AJHajh-20220125-ArunCrem Planning Response_LPA.docx

Y/184/21/DOC – CONDITIONS 8, 9 AND 10: DRAINAGE RESPONSE

Thank you for returning comments from your Drainage Engineer pertaining to planning conditions 8, 9 and 10 under planning permission Y/184/21/DOC for the Crematorium, Bognor.

Project No.	Originator	Volume	Lvl/Loc	Type	Role	Number	Rev
13591	CRH	XX	XX	DR	C	5050	P6

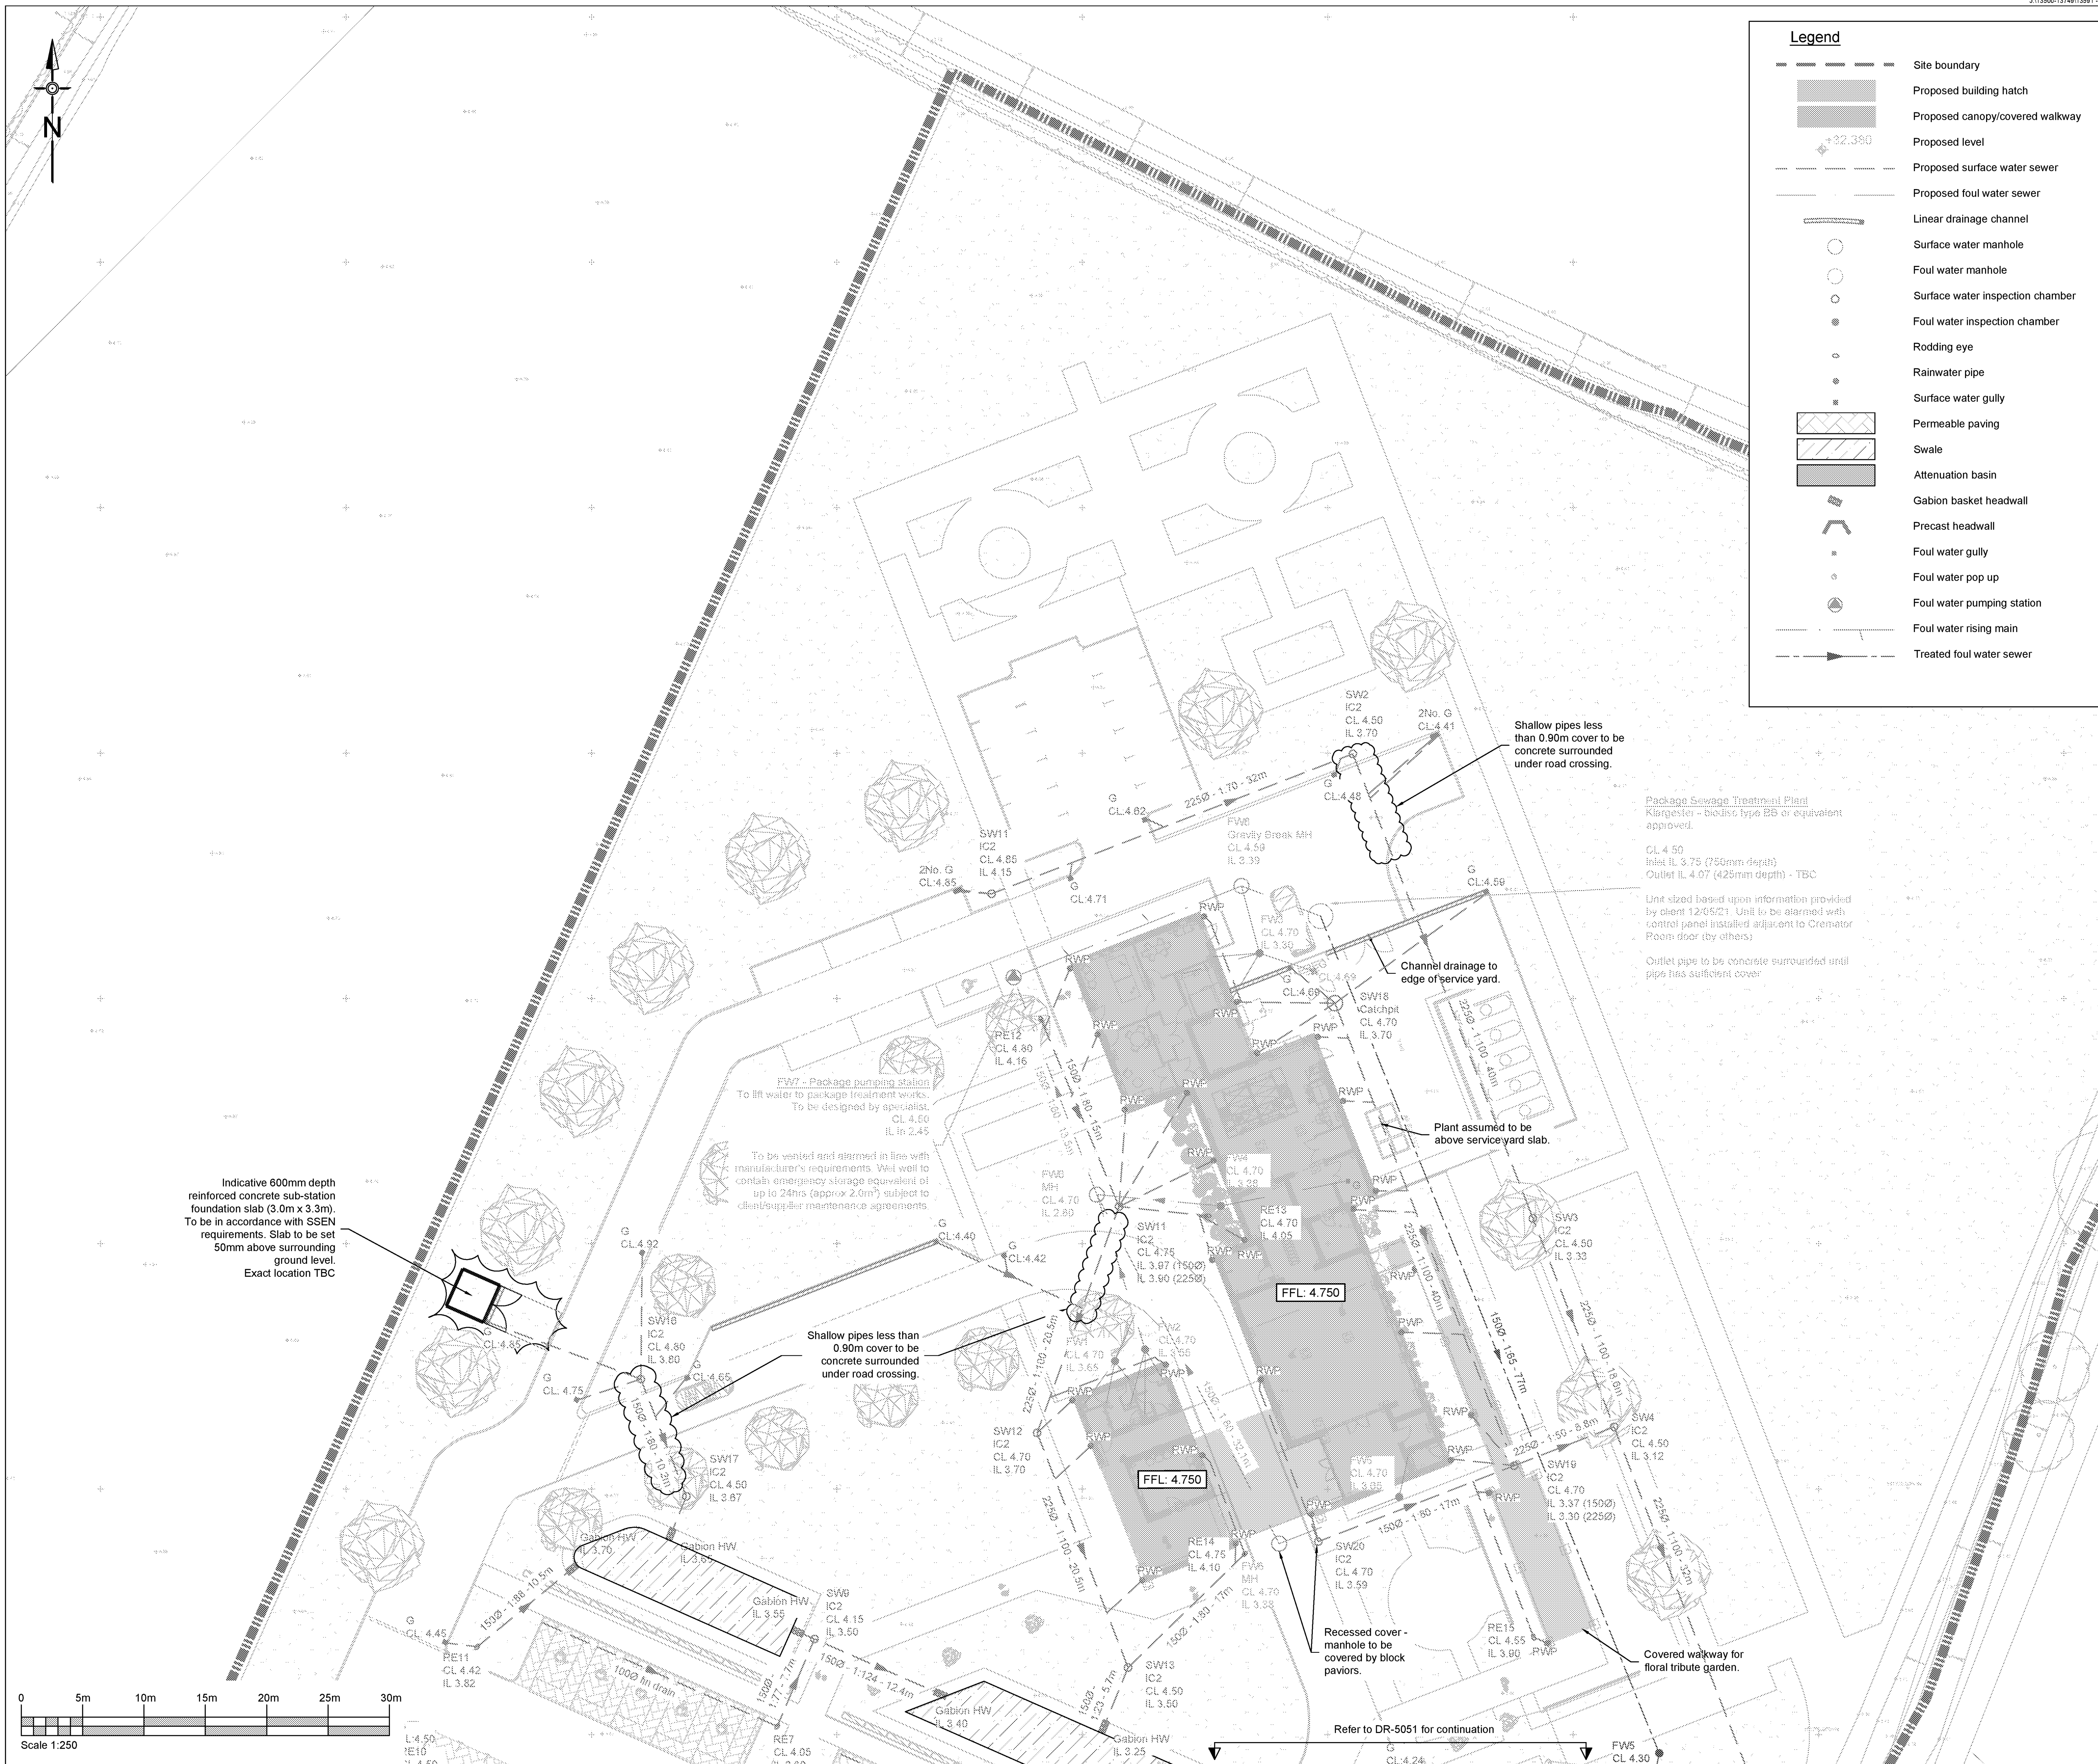
- 1. Please supply results of winter groundwater monitoring and winter infiltration testing.*
- 2. Please supply calculations to support design.*
- 3. Please supply an impermeable area catchment plan.*
- 4. Please label all pipes with diameter and fall.*
- 5. Hydrobrake unit references should be included on layout plans.*
- 6. Please label finish and formation level of permeable paving.*
- 7. Gullies and channel drains should be labelled with cover levels.*
- 8. The gabion outfall construction detail drawing is unclear. Is it proposed to have buried pipes discharging to the basin?*

3. Please see enclosed impermeable area plan 13591-CRH-XX-XX-DR-C-5250 Revision P1.
4. Additional pipe labels have been added to drainage layout plans 13591-CRH-XX-XX-DR-C-5050 Revision P6 and 5051 Revision P5. Gradients for short (<5m) pipe lengths have not been shown. Pipe sizes, maximum grades and materials are to be as specified on drainage notes drawing 13591-CRH-XX-XX-DR-C-5300 Revision P1 previously provided.

7. Cover levels have been provided for proposed gullies on updated drainage layout plan *13591-CRH-XX-XX-DR-C-5050 Revision P6* and *5051 Revision P5*. Channel drain cover levels will necessarily vary along the length and hence have not been provided. Exact levels will be determined by contractor to suit the finished levels as shown on levels plan *13591-CRH-XX-XX-DR-C-5200 Revision P3*.

P6	Revised to suit LLFA comments	21.01.22	SH
P5	RWP added as clouded. Reissued for Tender	25.11.21	AJH
P4	VE updates incorporated. Reissued for Tender	24.11.21	SH
P3	Client comments added. Reissued for Tender	15.09.21	AN
P2	Issued for Tender	09.07.21	SH
P1	Issued for Tender	05.07.21	AJH
Rev	Description	Date	By

Project No.	Originator	Volume	Lvl/Loc	Type	Role	Number	Rev
13591	CRH	XX	XX	DR	C	5051	P5

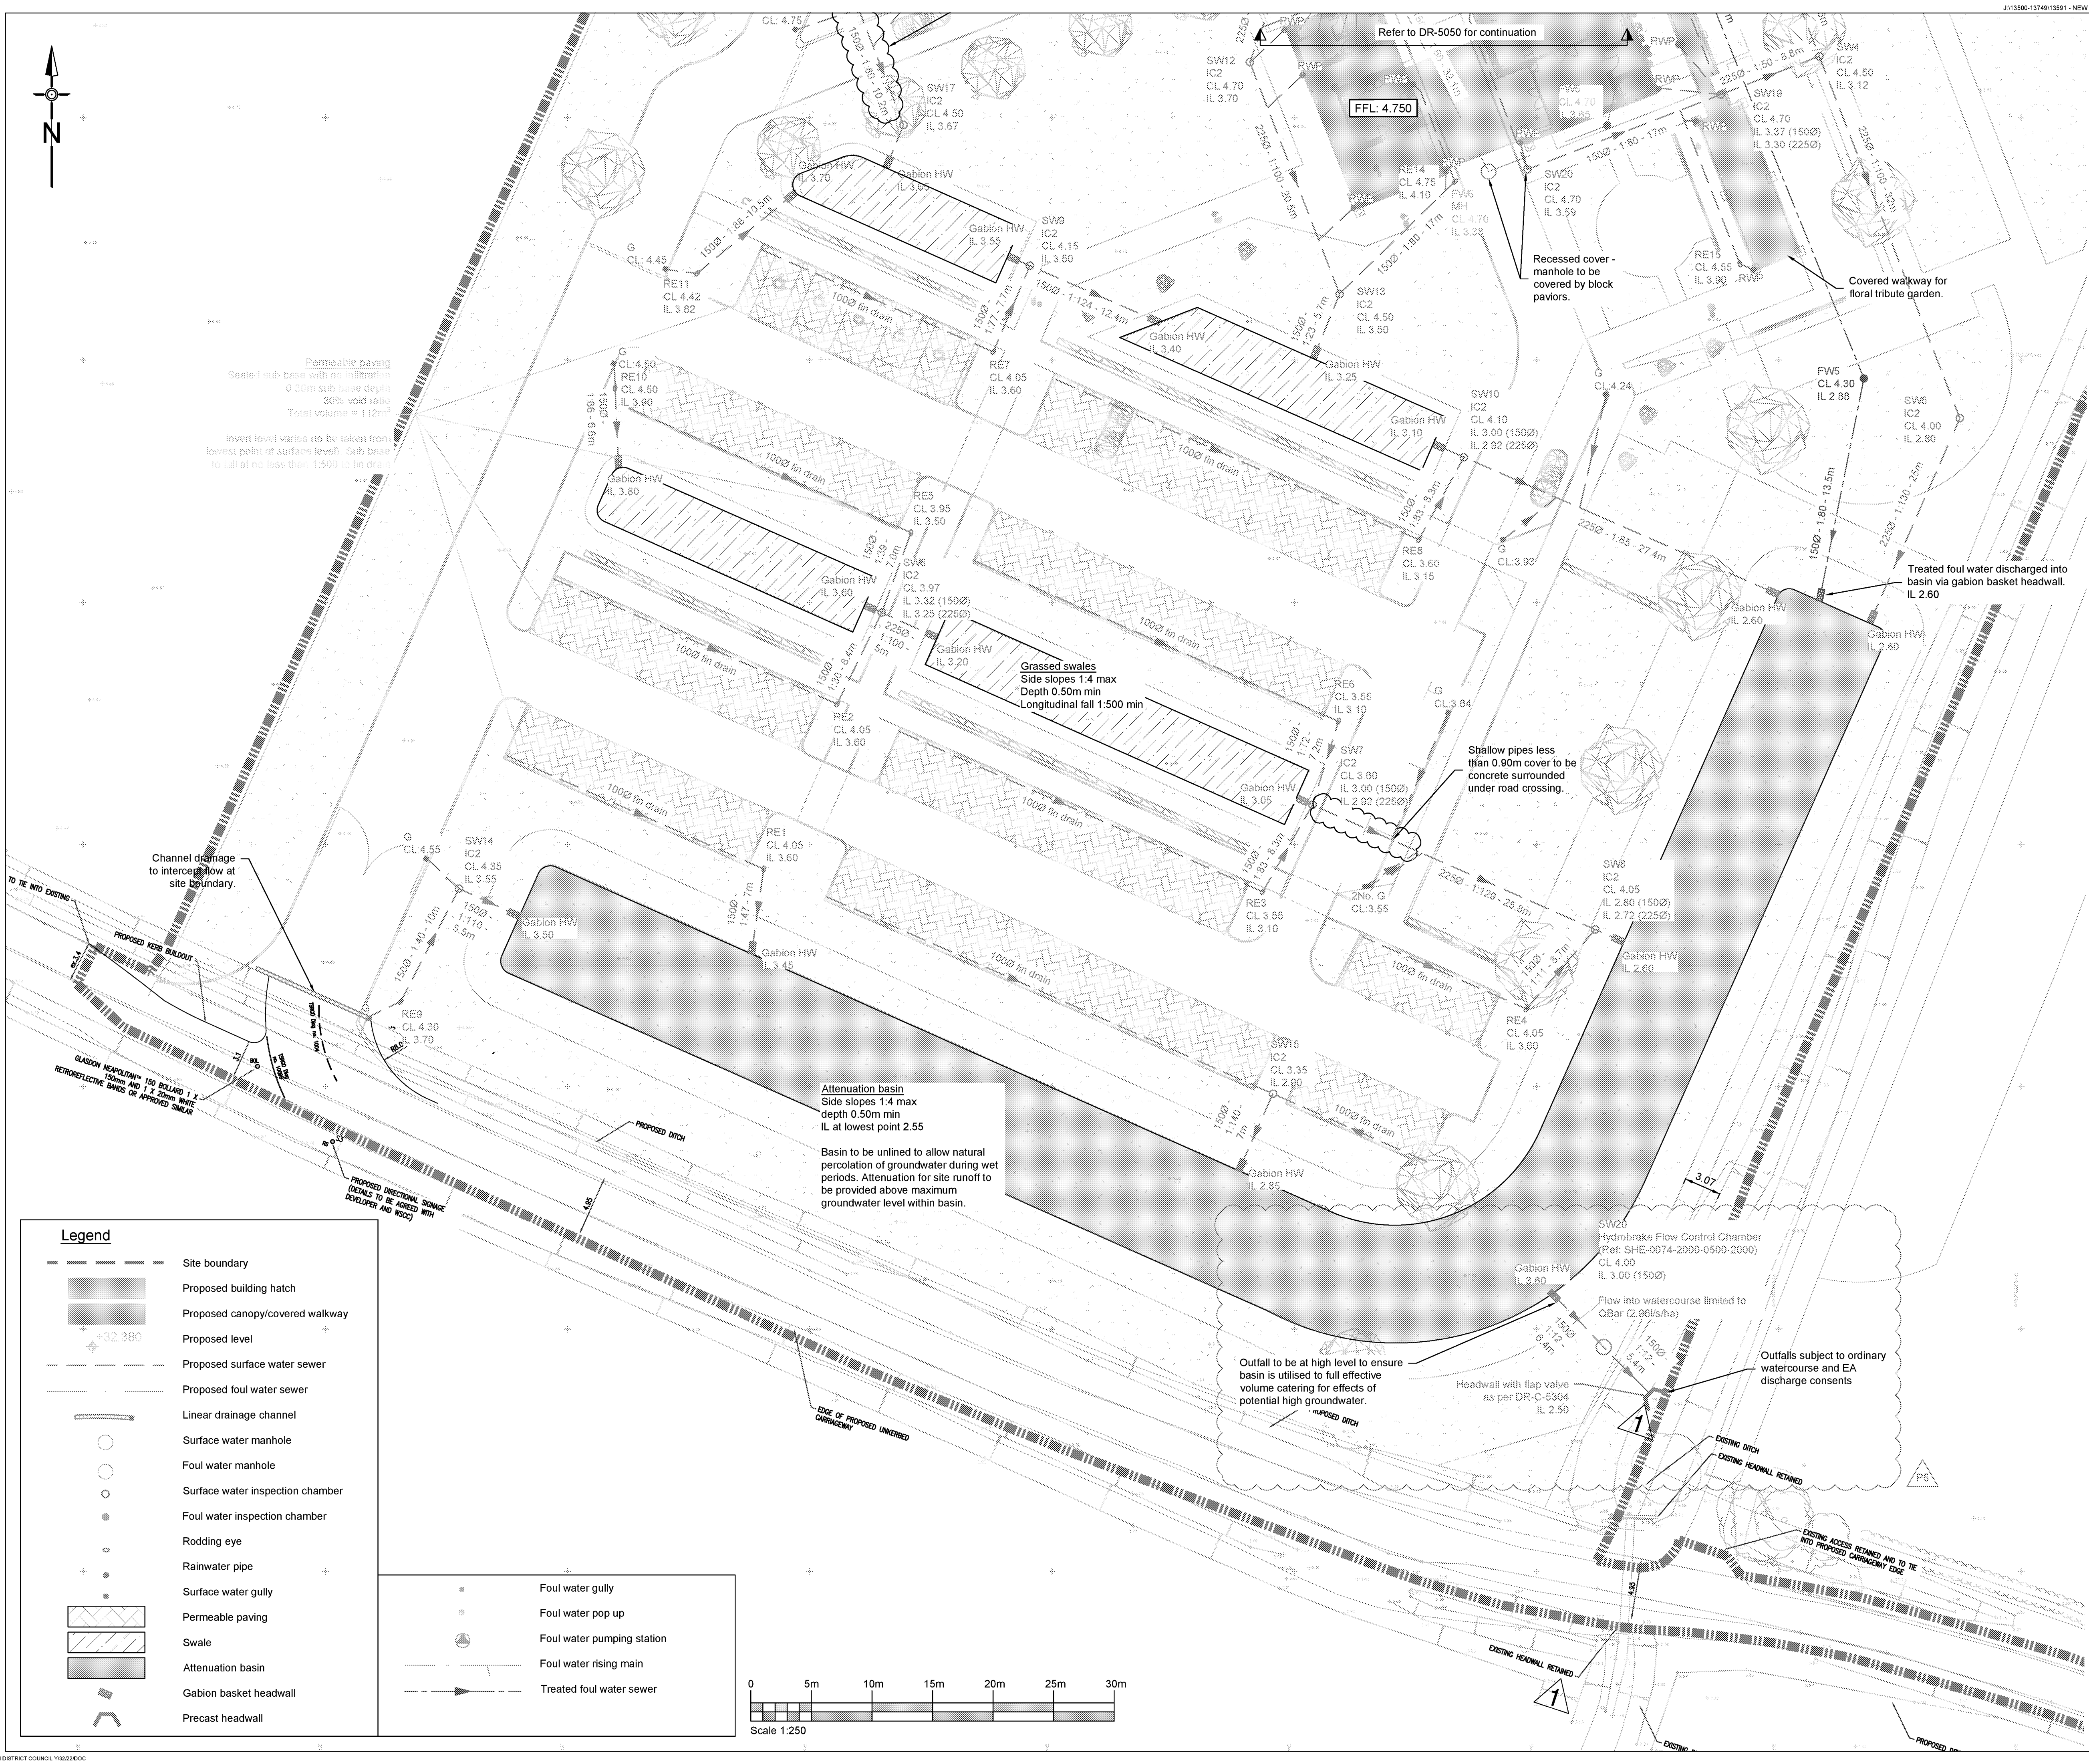
1. Please supply evidence of consent applications for the new ditch, and headwall to the existing ditch.
2. Please supply a buffer plan to show that at least 3m is being provided between top of bank of watercourses and obstructing features, such as fences, buildings, and basins.

5. Details have been added to updated drainage layout plan 13591-CRH-XX-XX-DR-C-5051 Revision P5.
6. Permeable pavement details have been previously provided on detail drawing 13591-CRH-XX-XX-DR-C-5350 Revision P2. This includes depths of proposed pavement build-up. The proposed surface levels can

1. OWC application for the discharge headwall from the basin was formally submitted in September 2021 together with all information requested by Paul Cann as per his email of 11th August 2021. Referring to Land Drainage Act 1991 Section 23(3), could you please confirm when consent letter will be issued?
2. The OWC consent for the new ditch is as shown on the attached consent (Consent Number LDC/ARUN/2021/015)
3. A suitable buffer has been provided between top of basin and edge of watercourse to allow for maintenance, as shown on drawing *13591-CRH-XX-XX-DR-C-5051 Revision P5*.

P5	Revised to suit LLFA comments - pipe details and basin information added	21.01.22	SH
P4	VE updates incorporated. Reissued for Tender	24.11.21	SH
P3	Client comments added. Reissued for tender	15.09.21	AN
P2	Issued for Tender	09.07.21	SH
P1	Issued for Tender	05.07.21	AJH
Rev	Description	Date	By
